**ADDENDUM
NO. 3**

September 11, 2024

**LOGANSFORT JR. HIGH SCHOOL RENOVATIONS
Logansport, IN 46947**

© GIBRALTAR DESIGN SHEET
A MV101

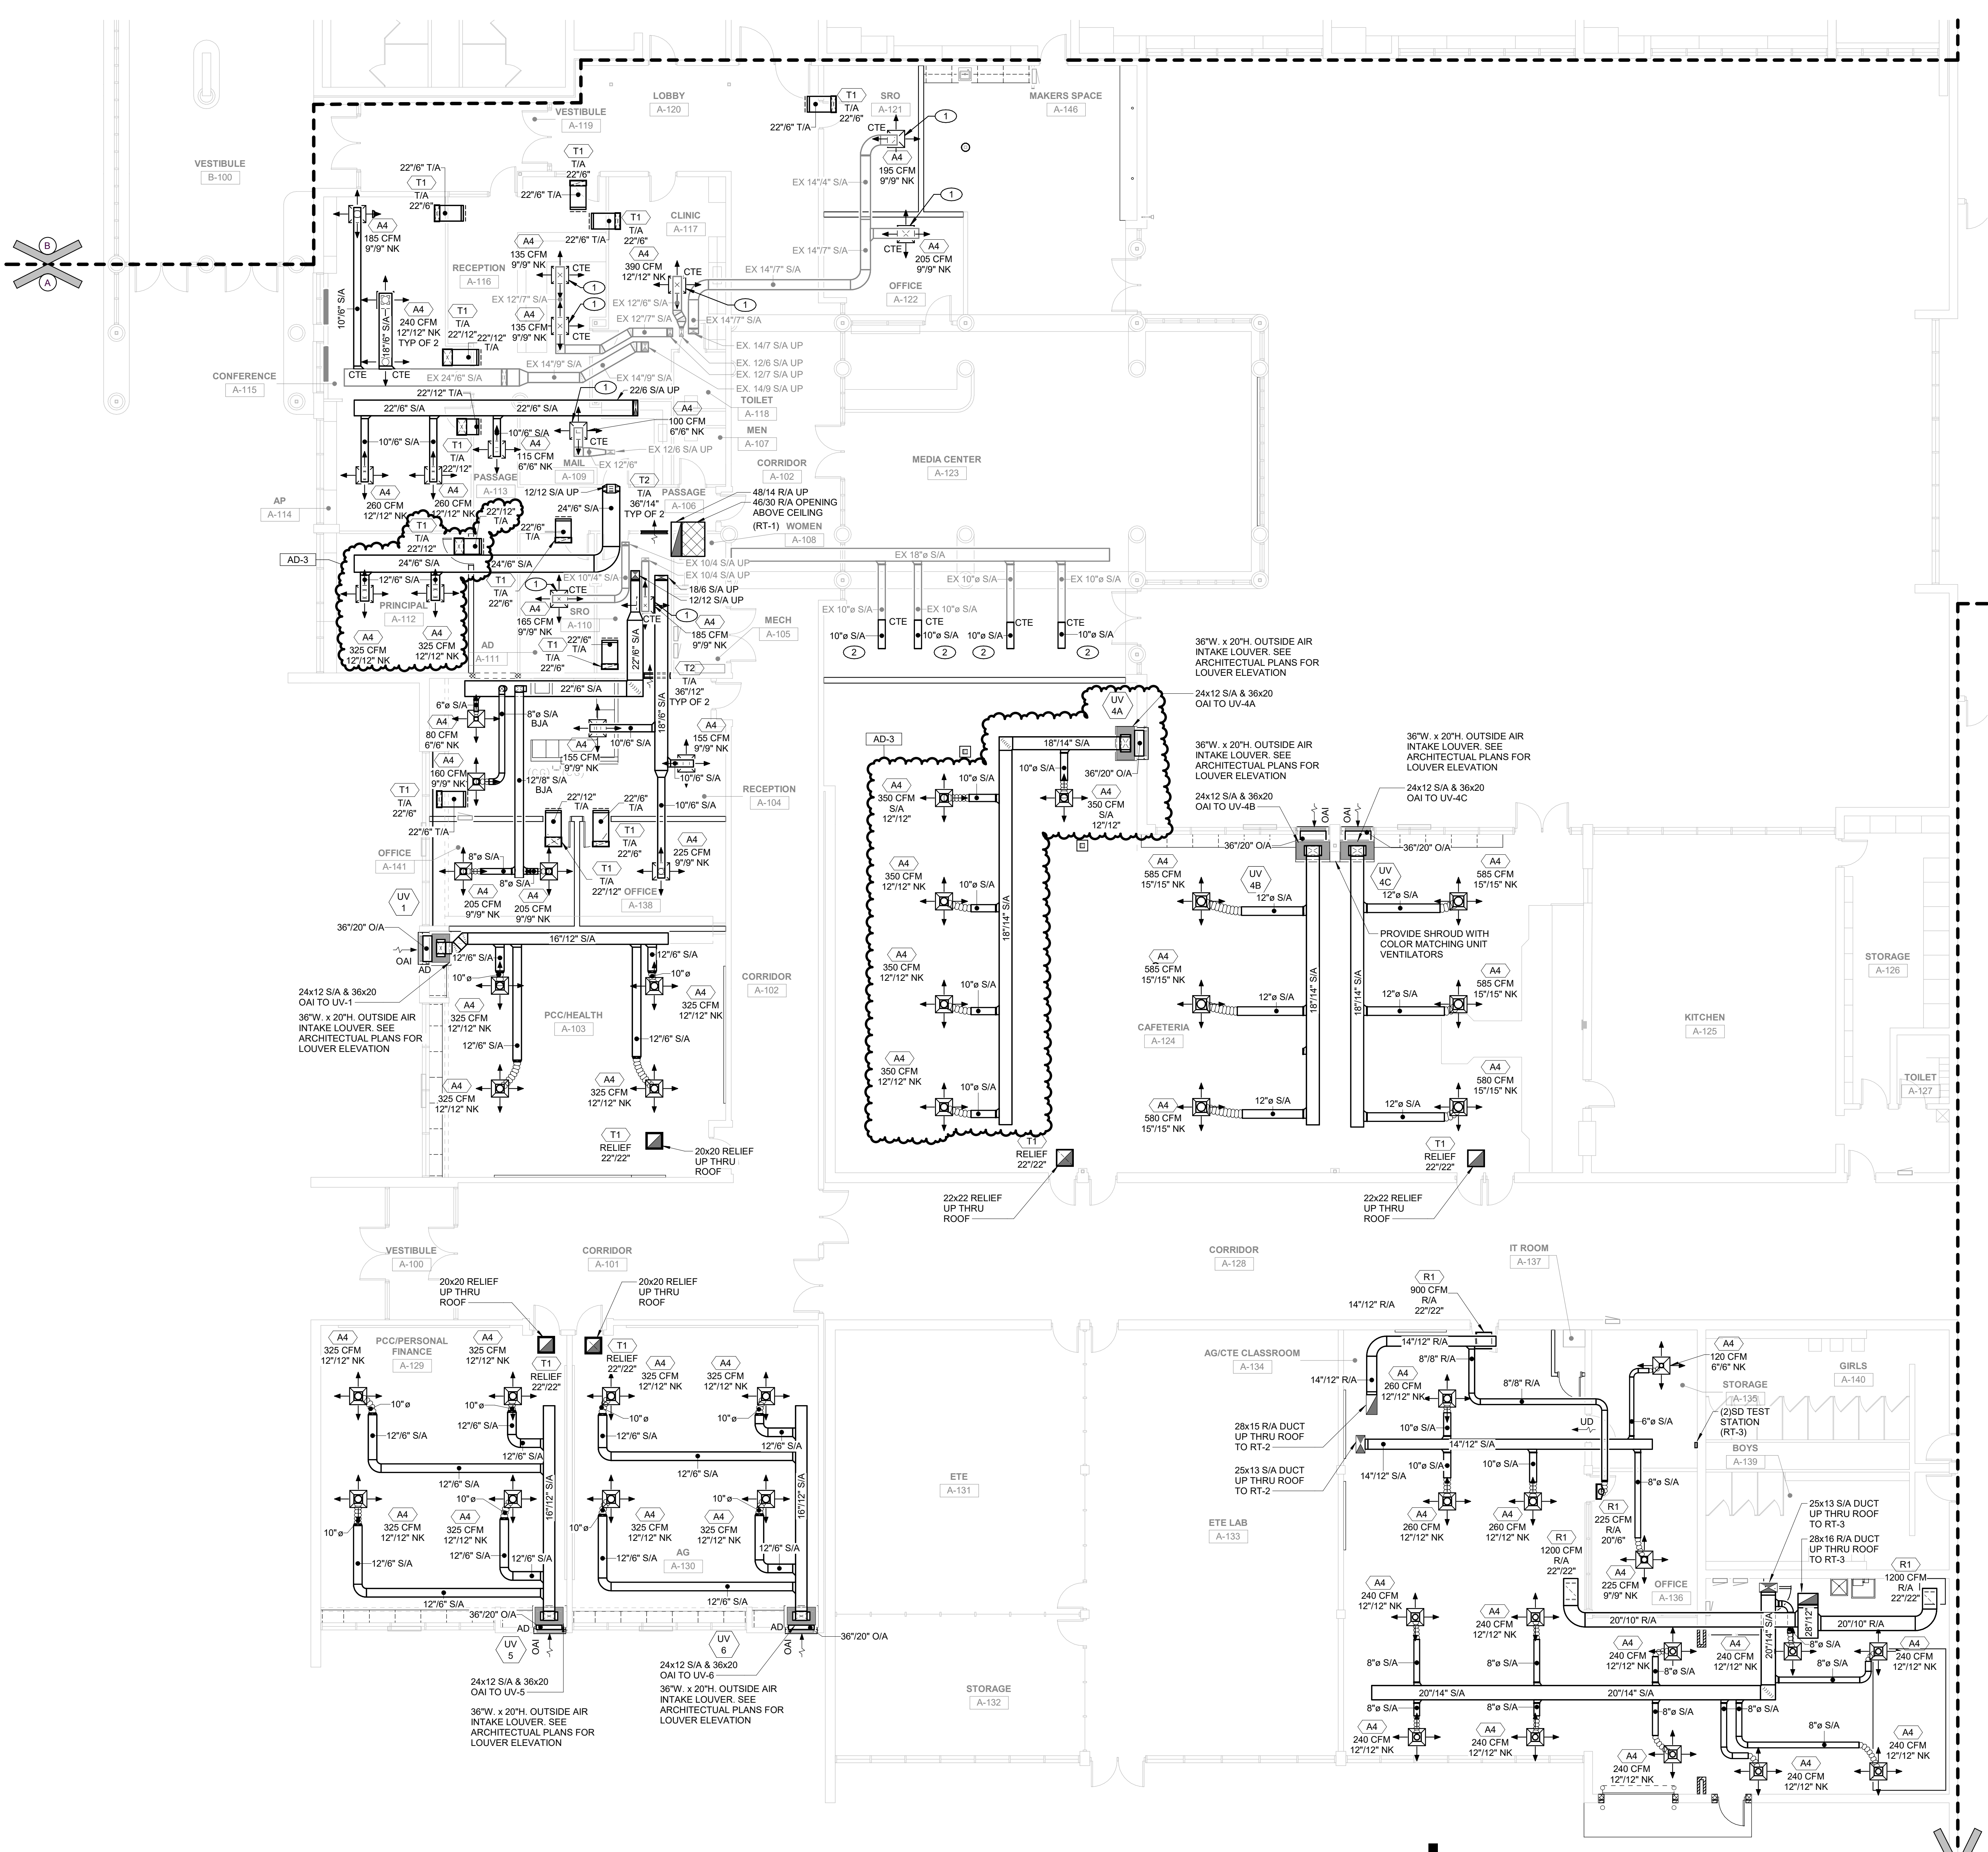
- A. Revised ductwork layout to accommodate for new wall added in room principal A-112.
- B. Added diffusers to UV-4A serving in Cafeteria A-124.
- C. Revised locations of diffusers to work with new lighting layout.

SHEET
C MV102

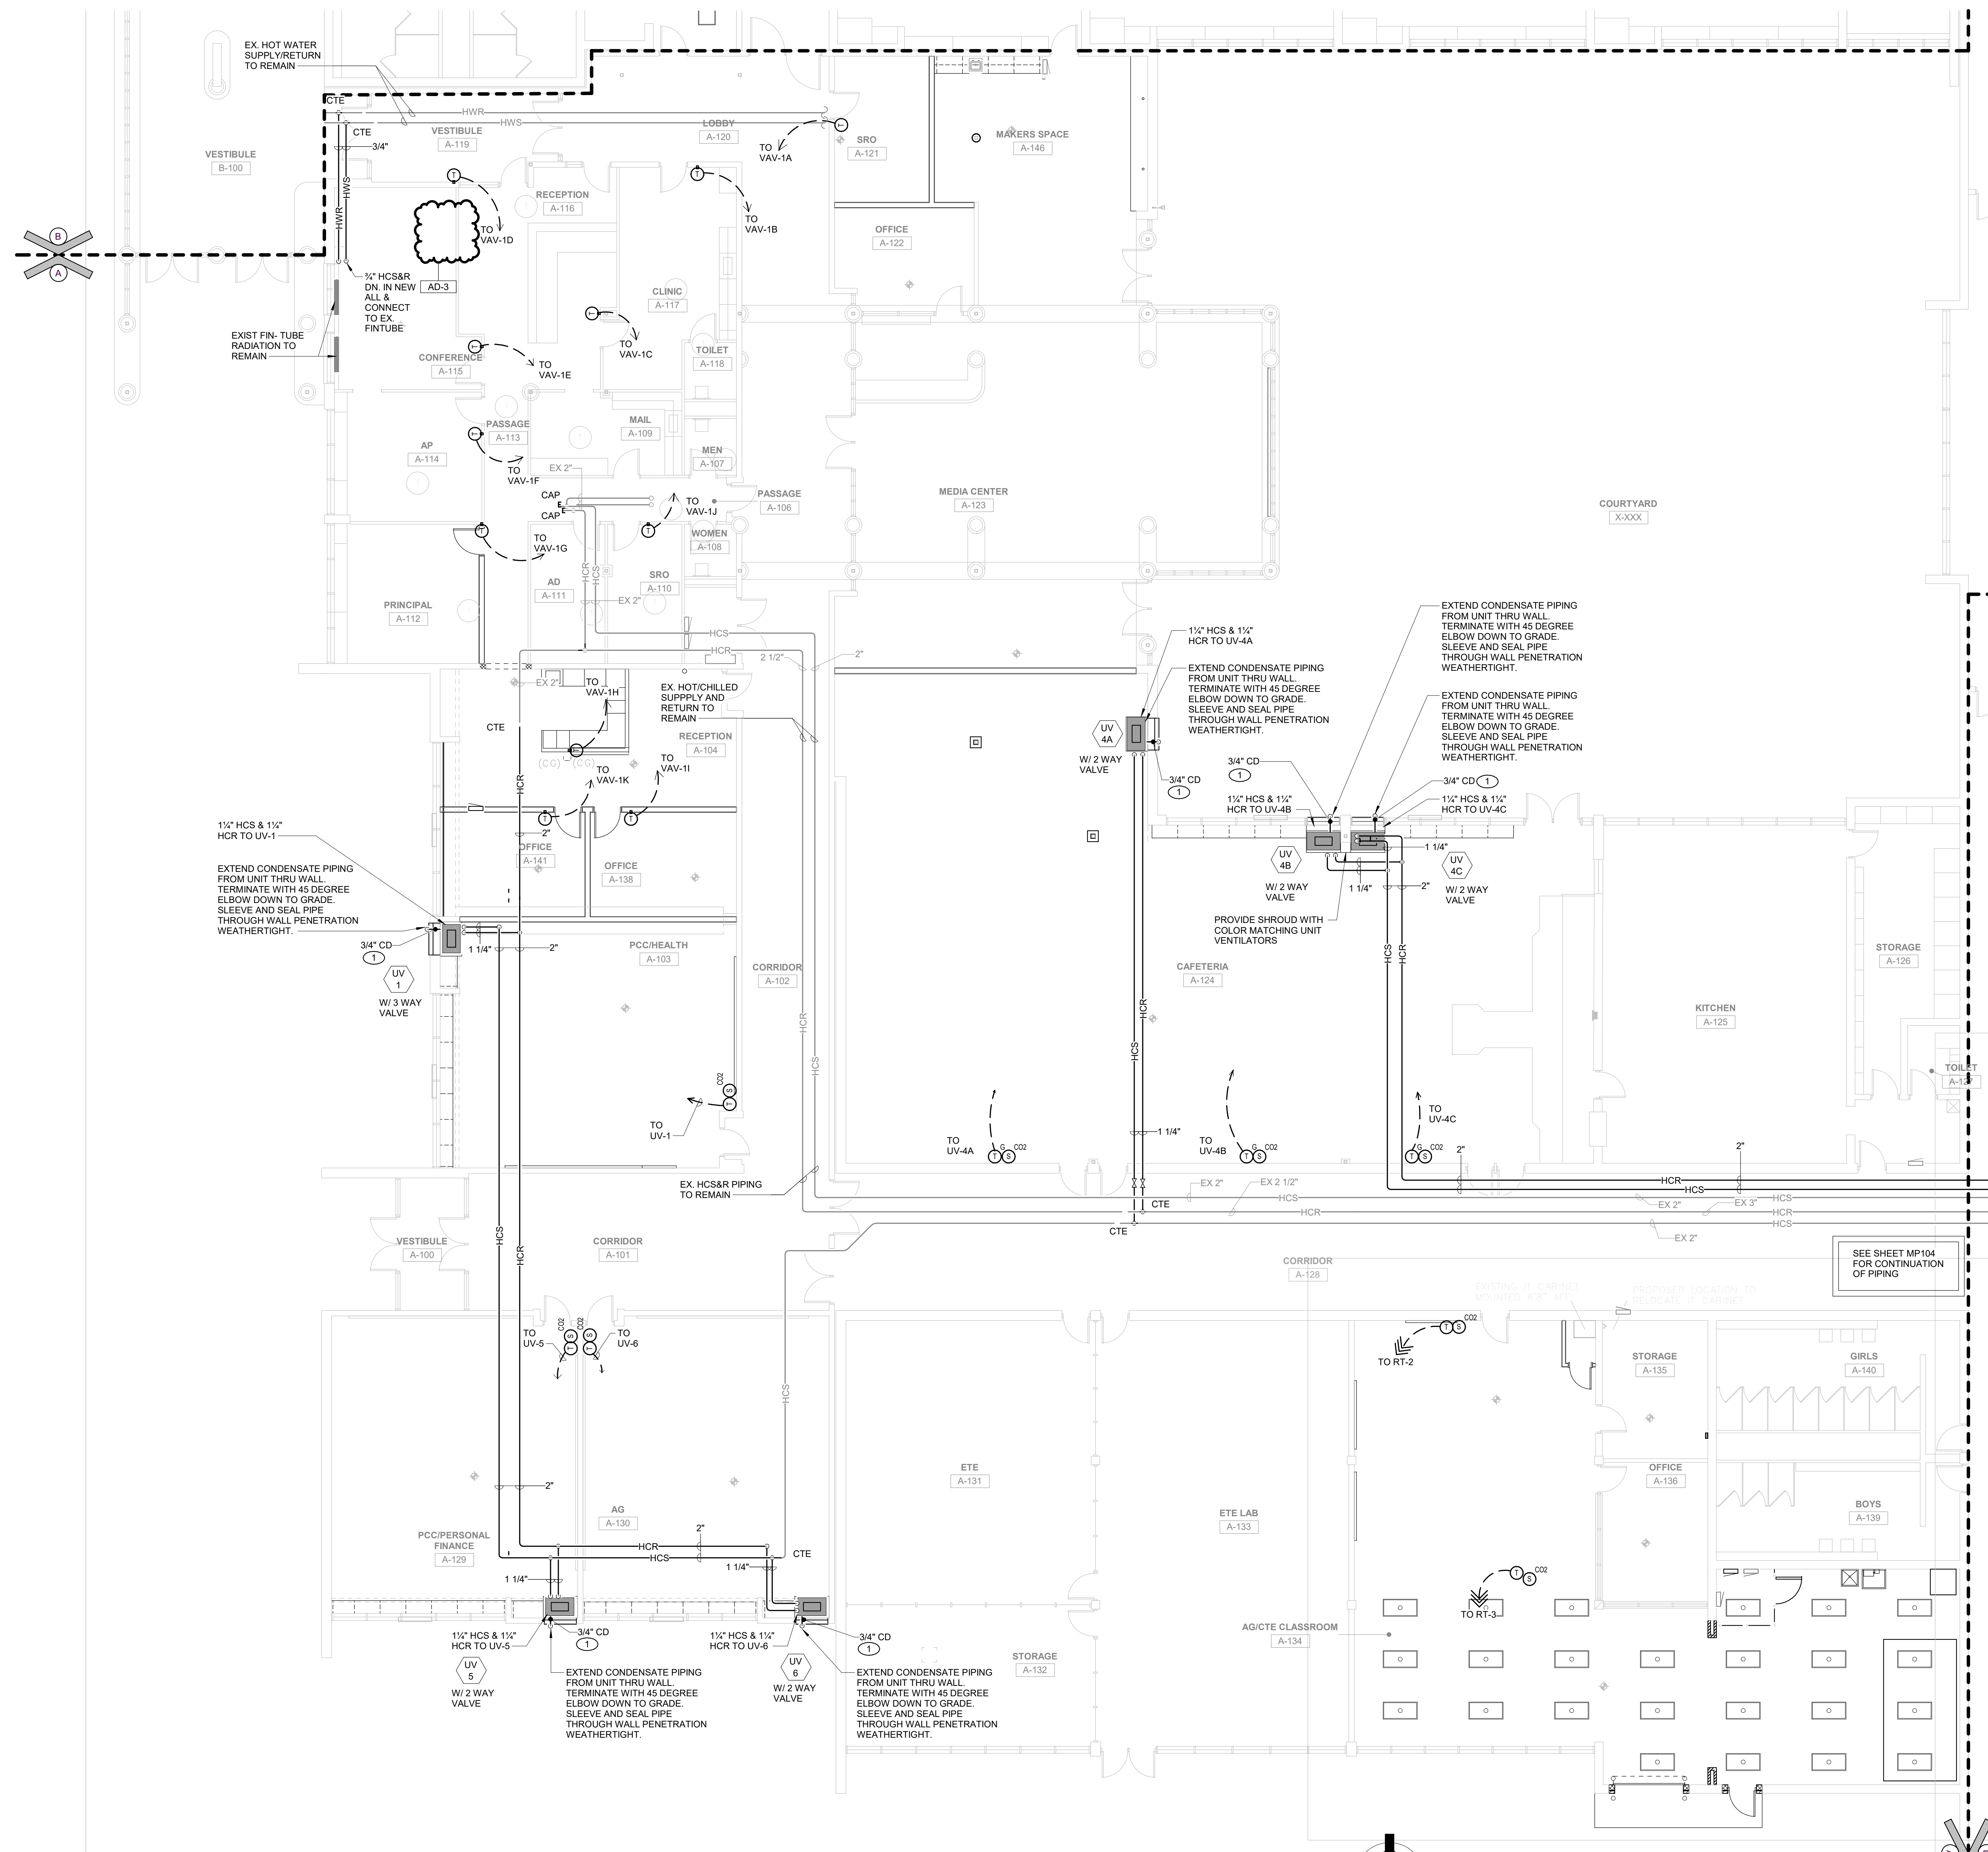
- A. Revised locations of diffusers to work with new lighting layout.

GIBRALTAR DESIGN SHEET E-001

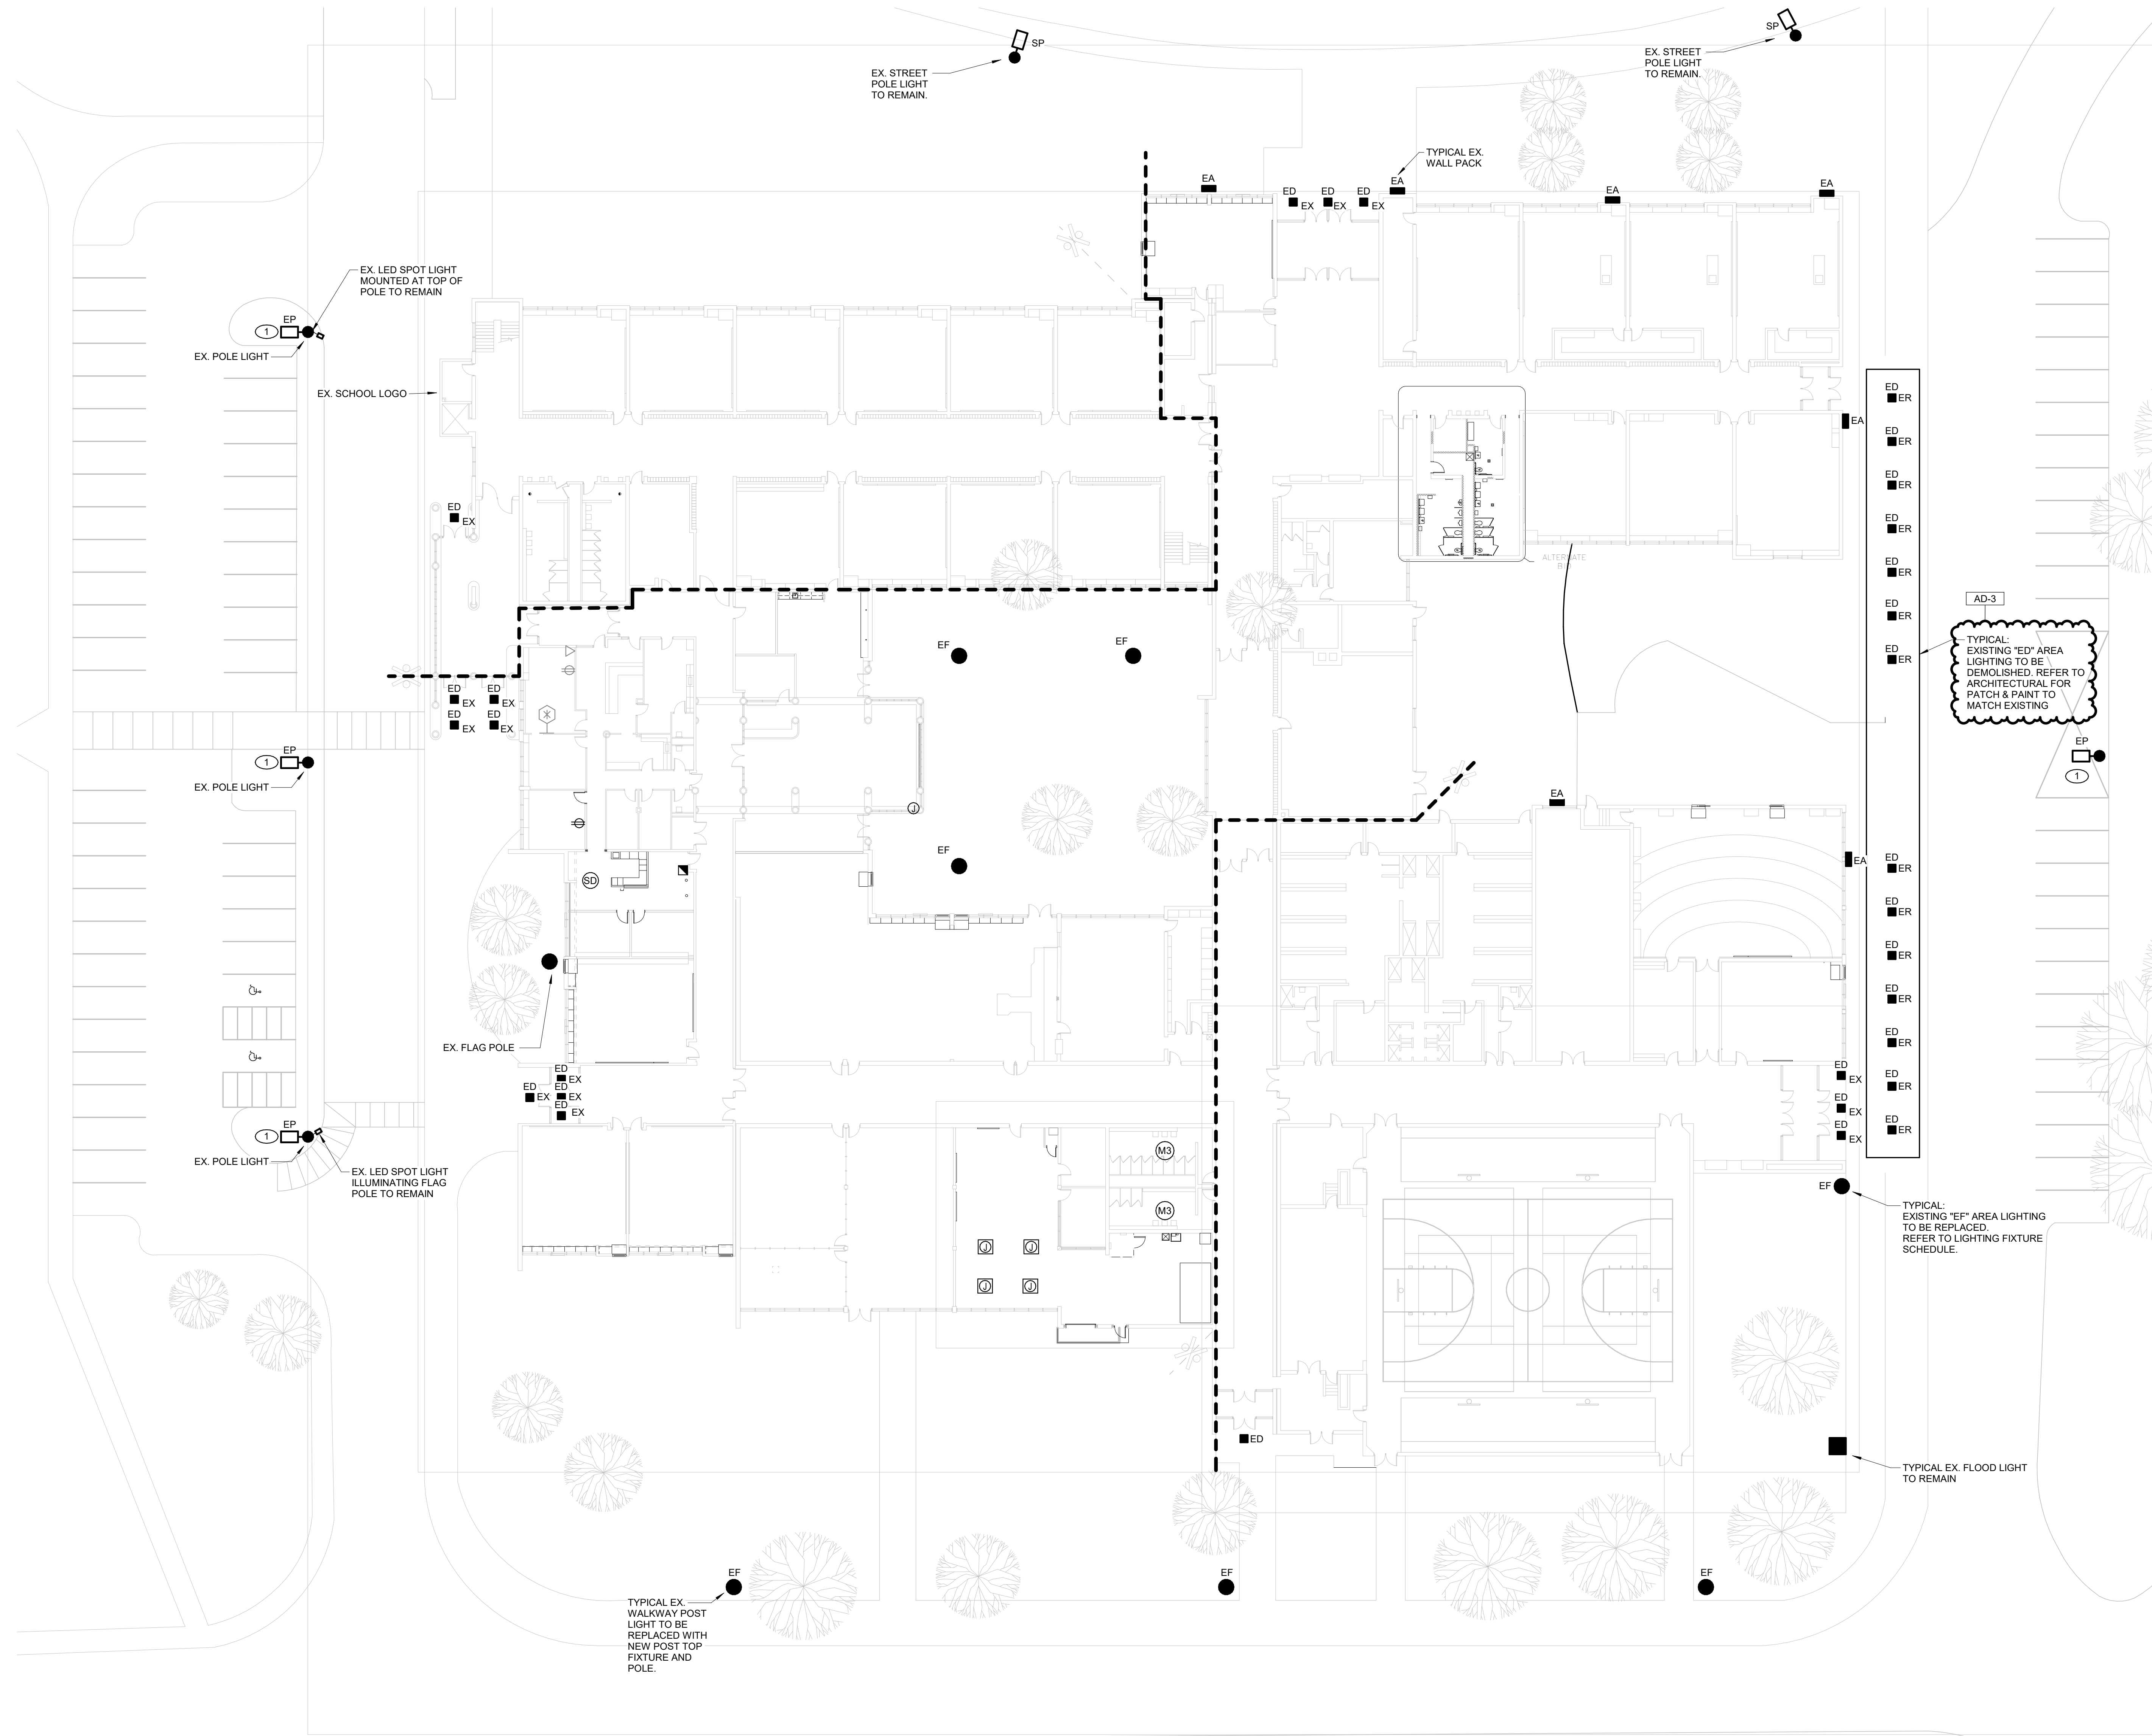
- A. Added exit sign symbol and reference to fixture schedule. Revised data cable quantity requirements.
- B. Clarification for all EM lights in corridors to be night lights.
